Subject: Y/22/19/PL – Demolition of existing redundant garage building & erection of 1 No. dwelling and associated works (alternative following Y/68/17/PL)

Having now had chance to review the submitted report entitled 'Combined Geotechnical and Ground Contamination Risk Assessment and Remediation Strategy' [Report Ref: R18-13073 Dated 10/07/2018] I will state the following:

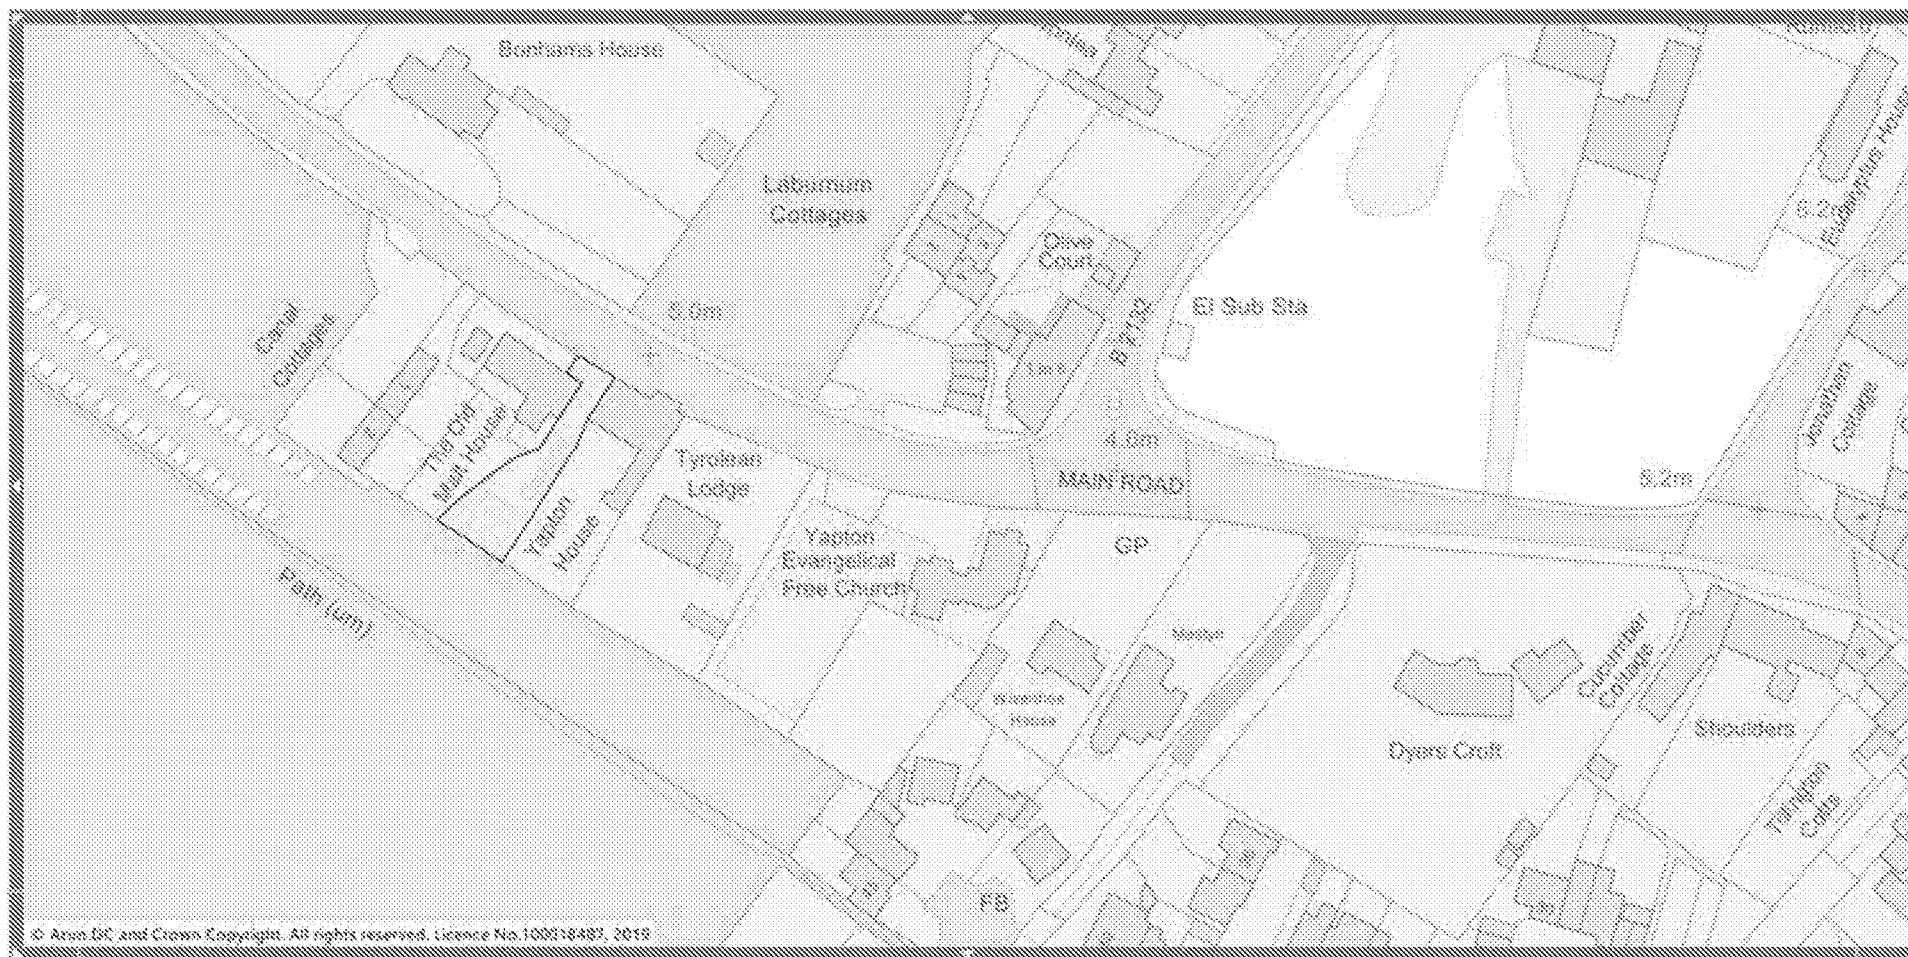
The embedded plan below shows the site in question and the yellow polygon that bounds the site symbolises that the land in question has been identified by the Council as Potentially Contaminated Land (PCL) [Ref: PCL 317]

Table 18. Post Remediation Conceptual Model for End Users – Potential Pollutant Linkages and Assessment of Risk

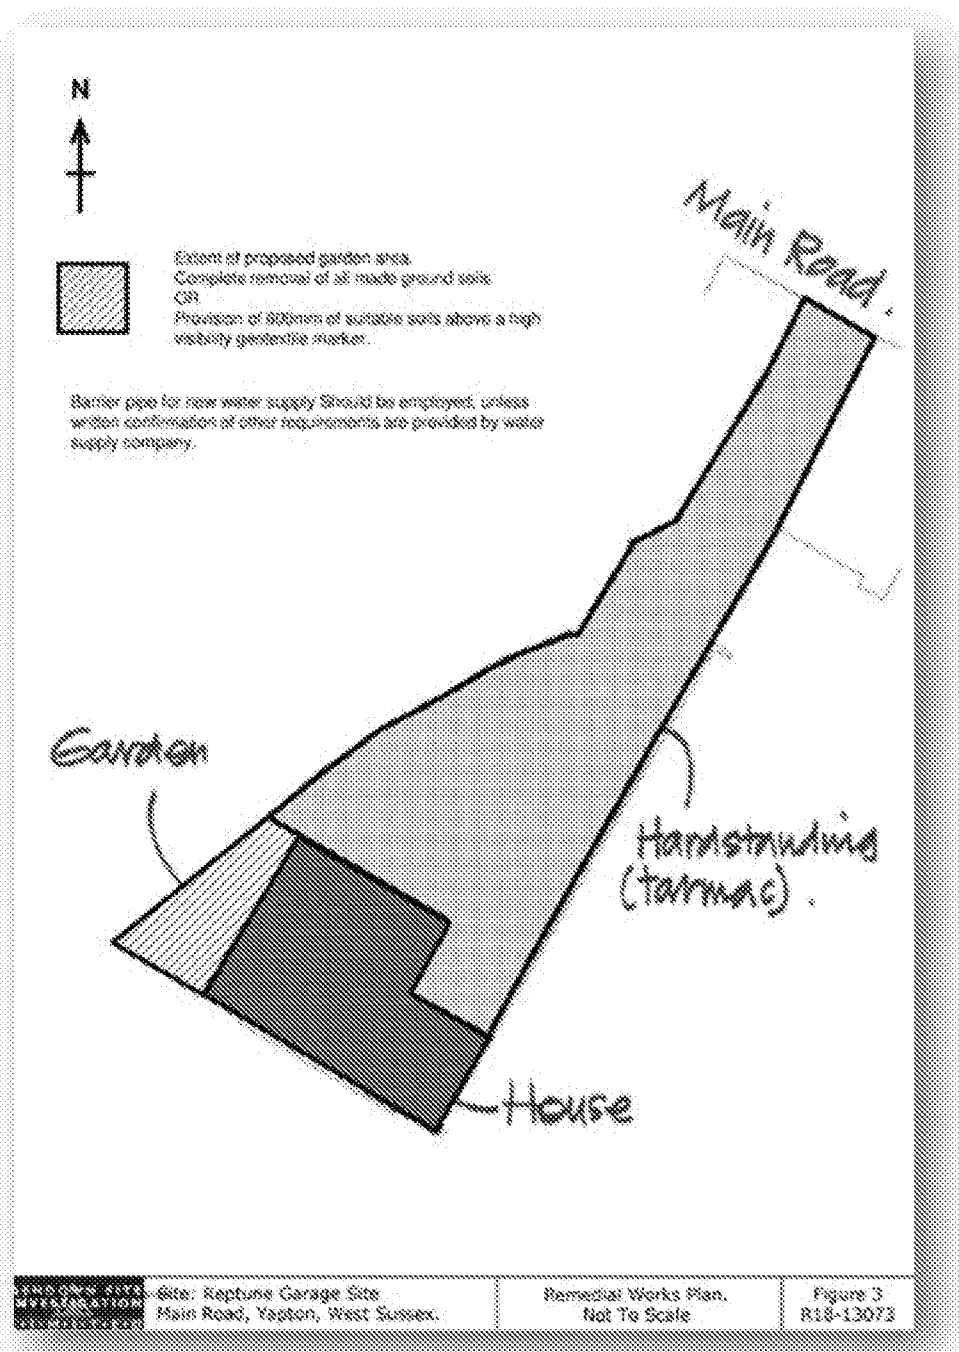
If one or other of the two options as stated within section 12.1 'Options Appraisal' as set out under the proposed section 12. 'Remediation Strategy' of the report are followed by the construction contractors to give the reported outcome as set-out in section 14 as shown below; as well as retaining the site orientation as shown in Figure 3 herein with no deviation without prior written consent from the Planning Authority, then the Environmental Health department is satisfied that the contamination will be removed / encased with hardstanding thereby removing the pollutant linkages for this site...

Having said that, if during development, any visible contaminated or odorous material, (for example, asbestos containing material, stained soil, petrol / diesel / solvent odour, underground tanks or associated pipework) not previously identified, is found to be present at the site, no further development (unless otherwise expressly agreed in writing with the Local Planning Authority) shall be carried out until it has been fully investigated using suitably qualified independent consultant(s). The Local Planning Authority must be informed immediately of the nature and degree of the contamination present and a method statement detailing how the unsuspected contamination shall be dealt with must be prepared and submitted to the Local Planning Authority for approval in writing before being implemented. **Reason: To protect the amenity of local residents in accordance with Policy QE DM4 of the Adopted Arun Local Plan 2011 – 2031**

A 'Verification Report' demonstrating completion of the works set out in the approved remediation strategy and the effectiveness of that remediation shall be submitted to and approved in writing by the Local Planning Authority. The report shall include results of sampling and monitoring carried out in accordance with the approved verification plan to demonstrate that the site remediation criteria have been met. The report shall also include a 'long-term monitoring and maintenance plan' for longer-term monitoring of pollutant linkages, maintenance and arrangements for contingency action, as identified in the verification report, and for the reporting of this in writing to the Local Planning Authority. **Reason: To protect the amenity of local residents in accordance with Policy QE DM4 of the Adopted Arun Local Plan 2011 – 2031**
